Access Compliance Report

Public Rights-of-Way

(Curb Ramps)

Intersection ID: 47452	Main Street: WHISTLING_SWAN_RD	Cross Street: MALLARD_LANDING_RD	Location: NW
ADA ID: 8505897B6086	Ramp Type: Perp	Initial Pass/Fail: Fail	Overall Compliance: No
Severity Score: 8.75			
Codes/Mitigation Info/Possible Solution		Field Measurements/Component Compliance

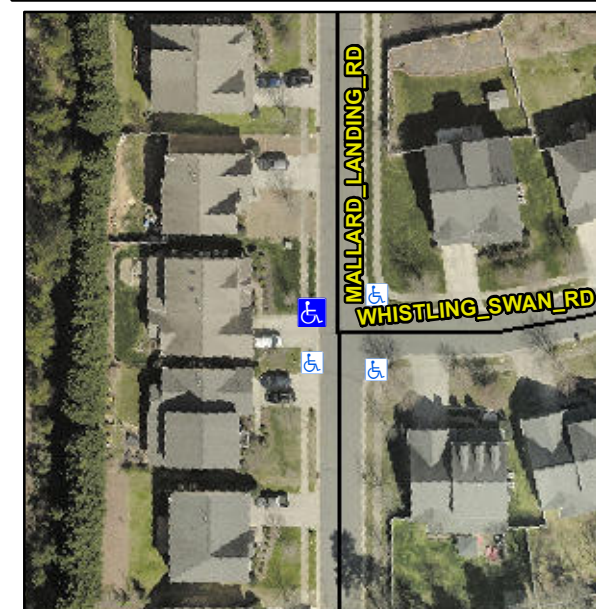
Not Found, R304.5.1

Compliance	Description	Data	Compliance	Description	Data
N/A	Ramp Length (in)	47.0	Yes	Ramp Slope (%)	6.4
No	Ramp Width (in)	46.0	Yes	Ramp XSlope (%)	1.3
N/A	Flare Type LT	N/A	N/A	Flare Type RT	N/A
N/A	Flare Slope LT (%)	N/A	N/A	Flare Slope RT (%)	N/A
N/A	Flare Traversable LT?	N/A	N/A	Flare Traversable RT?	N/A
N/A	Landing Length (in)	N/A	N/A	DWS Provided?	N/A
N/A	Landing Width (in)	N/A	N/A	DWS Contrast?	N/A
N/A	Landing Slope (%)	N/A	N/A	DWS Length (in)	N/A
N/A	Landing X Slope (%)	N/A	N/A	DWS Full Width?	N/A
N/A	Landing Curb? (Y/N)	N/A	N/A	DWS Offset (in)	N/A
N/A	Shared Landing?	N/A			
N/A	Gutter Ponding?	N/A	N/A	Gutter Slope (%)	N/A
N/A	Gutter Lip Ht (in)	N/A	N/A	Gutter X Slope (%)	N/A
N/A	Painted X Walk1?	No	N/A	Painted X Walk2?	N/A
	X Walk 1 Direction	To NE		X Walk 2 Direction	N/A
N/A	X Walk 1 Width (in)	N/A	N/A	X Walk 2 Width (in)	N/A
	X Walk 1 Slope (%)	0.6		X Walk 2 Slope (%)	N/A
	X Walk 1 X Slope (%)	1.0		X Walk 2 X Slope (%)	N/A

Remove & Replace Entire Ramp.
